February 23, 2017

RE: Zephyr Gold USA Ltd (Zephyr)
Dawson Gold Project P-2013-002
NOI Modification, Revision No. MD-3
Response to Second Notice of Deficiencies dated January 24, 2017

Figure 3: Estimated proposed new exploration roads lengths. Based on exploration activity performed to date, actual road constructed will likely be 25% less than projections.

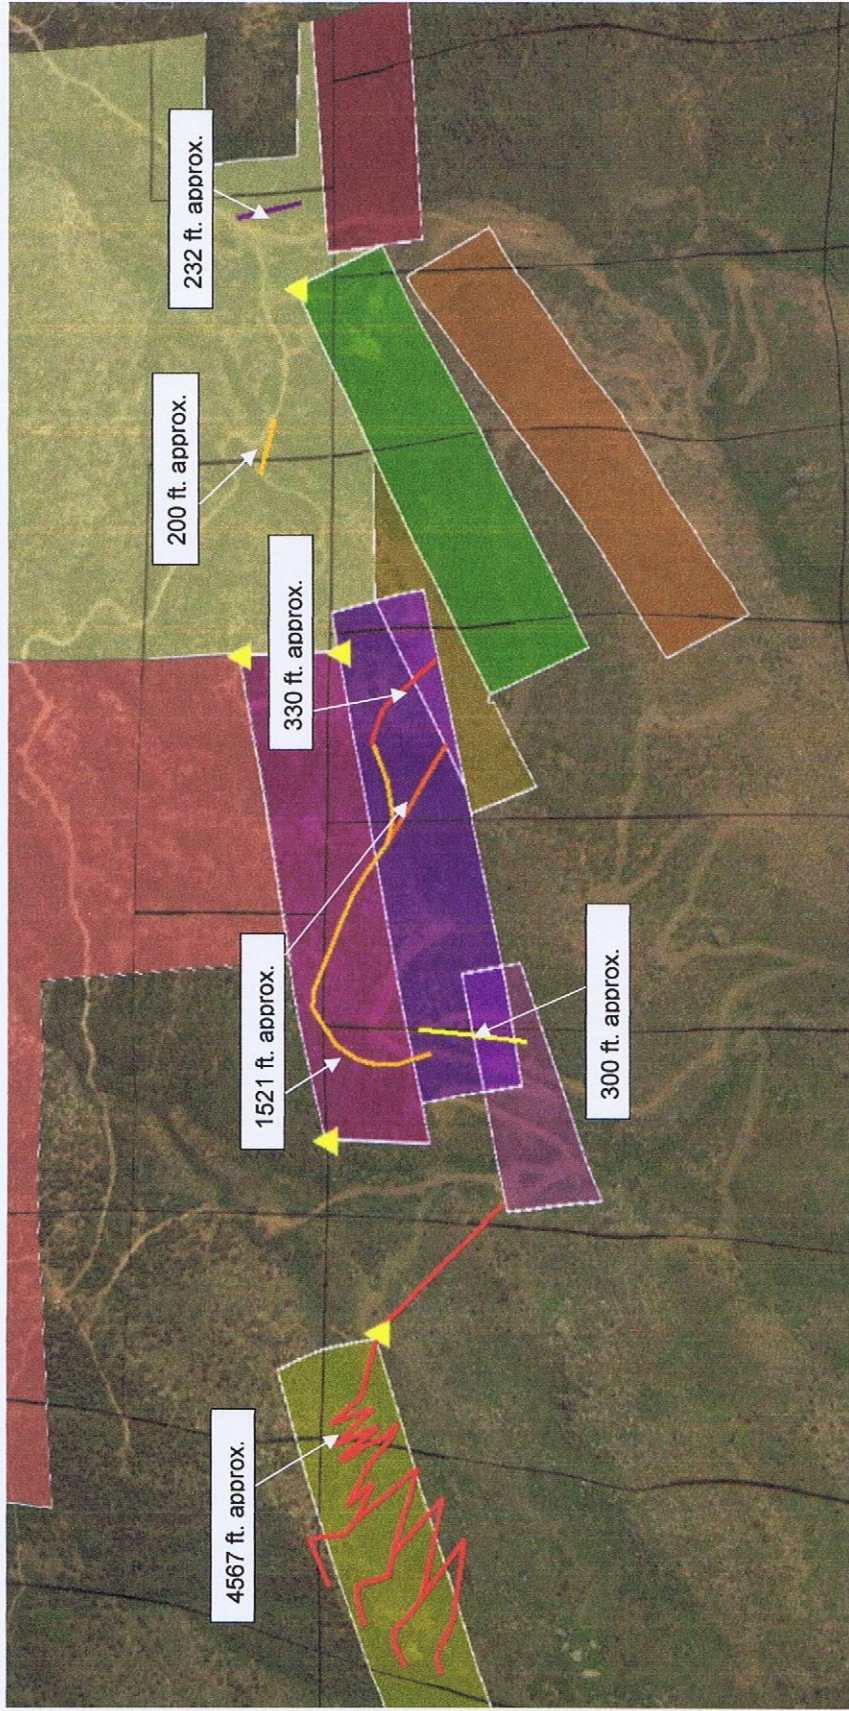
- a. The proposed road length was revised to 7,150 linear feet (Figure 3) with approximately 540 ft. (0.5 acres) proposed on public land. Approximately 1,330 ft. of the bonded 1700 ft. of road has been constructed to date. The proposed maximum total disturbance for all exploration, performed to date and proposed, is approximately 7.8 acres.

ZEPHYR MINERALS LTD 1300-1959 UPPER WATER STREET PURDY'S WHARF TOWER 1 HALIFAX, NS B3J 3N2 CANADA			
COLORADO DIVISION RECLAMATION MINING & SAFETY			
PROPOSED DRILL ROAD TYPICAL CROSS SECTION DAWSON MINE			
SCALE	JOB NO.	DATE	DRAWN BY / REVISED BY
1" = 10'		02-18-17	EAI/GVP
			GVP

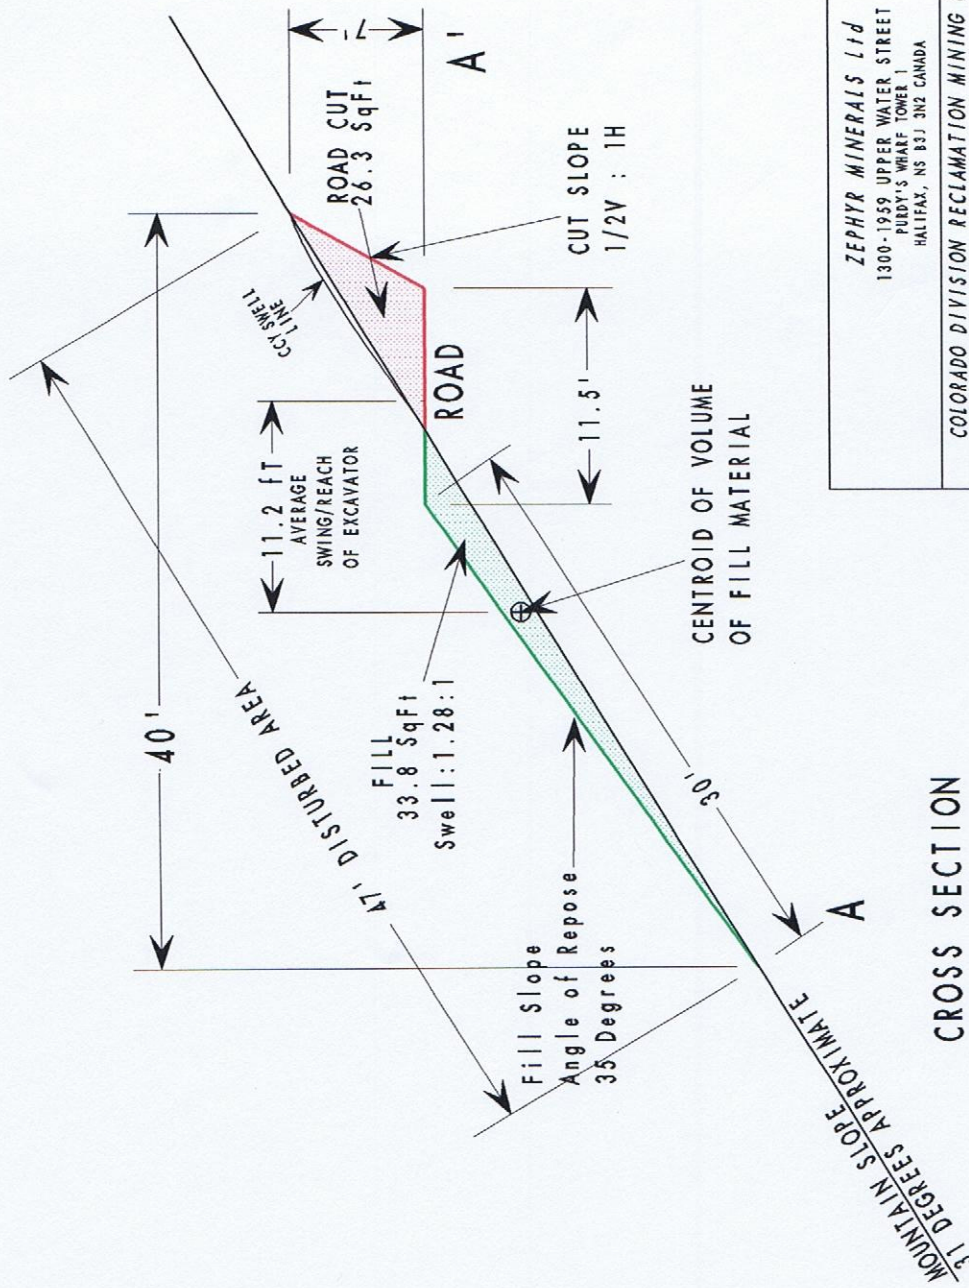
- 4. Road cut material will be placed down slope at the angle of repose as presented on Figure 4. The material will be replaced on the road cut and contoured to the natural slope during reclamation. Photo 1 is the drill pad constructed in 2013 showing natural revegetation of the repose material. Photo 2 is the same drill pad from the road below illustrating the steep grade, natural revegetation success and minimal erosion.

Because the project is located in an area of Cathedral rock outcrop, the majority of the road cuts are stable rock faces. During reclamation, road cut material that was pushed onto the repose area during construction will be pulled from the slope, placed in the road cut using a 324DL excavator with a 60 ft. reach, compacted and shaped with the excavator bucket. The mountainside road scenario limits operating space for what would typically utilize multiple pieces of equipment to perform reclamation. The 324DL excavator was chosen not only for its reach capability but also for its maneuverability in tight situations (Figures 4, 5 and 6).

TRAIL STABILIZATION SECTION FOR:	ZEPHYR GOLD
	FREMONT COUNTY, COLORADO
	SOIL/ROCK FILL BUTTRESS
	DETAIL

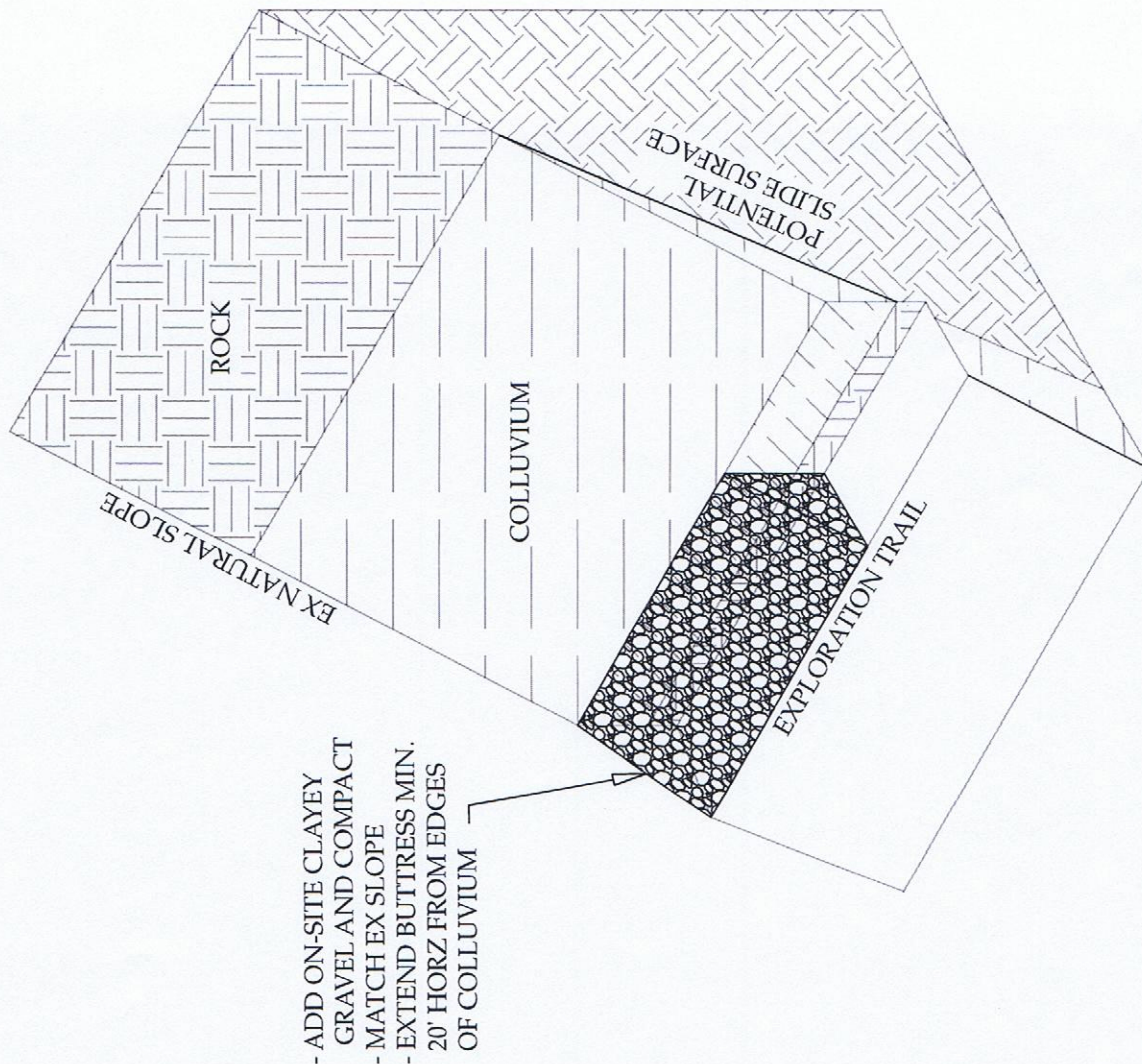
The areas of the road that do not extend through the rock generally cut through lenses of colluvium material underlain by rock. This colluvium does have a potential to slide along the rock contact in the cut areas due to the removal of the colluvium material. The colluvium generally consists of clay, silt, sand and angular cobbles up to 6 inches in diameter. No significant layering or separation of material types were observed within the colluvium and there were no signs of groundwater near the surface or in the cut areas.

To minimize colluvium/rock contact slippage a soil and rock buttress should be placed in the areas of the exploration trails that extend through the colluvium material. The rock buttresses should extend a minimum of 20 feet from each side of the colluvium material. An example rock buttress is shown on the attached Figure 1.

Photo 1: 2013 drill pad reused in 2016. Note natural revegetation of road surface, road cut material and road cut. Erosion channels are not present on the drill pad or road cut material. Drill cuttings are contained in plastic tubs

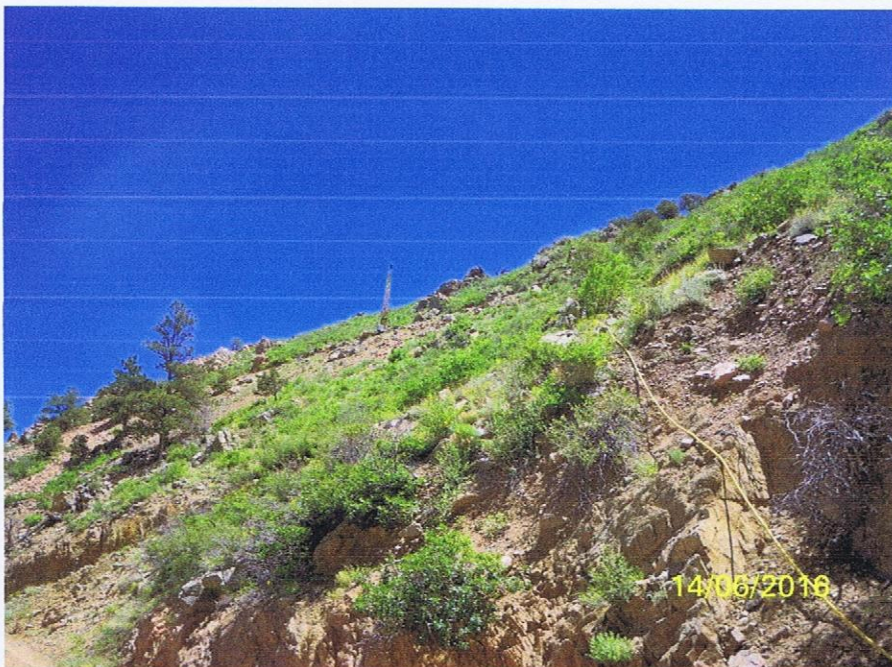
- 6. As presented in Photo 1, exploration drillers use plastic tubs for mud cuttings and water storage. Mud pits have not been used and will not be used.
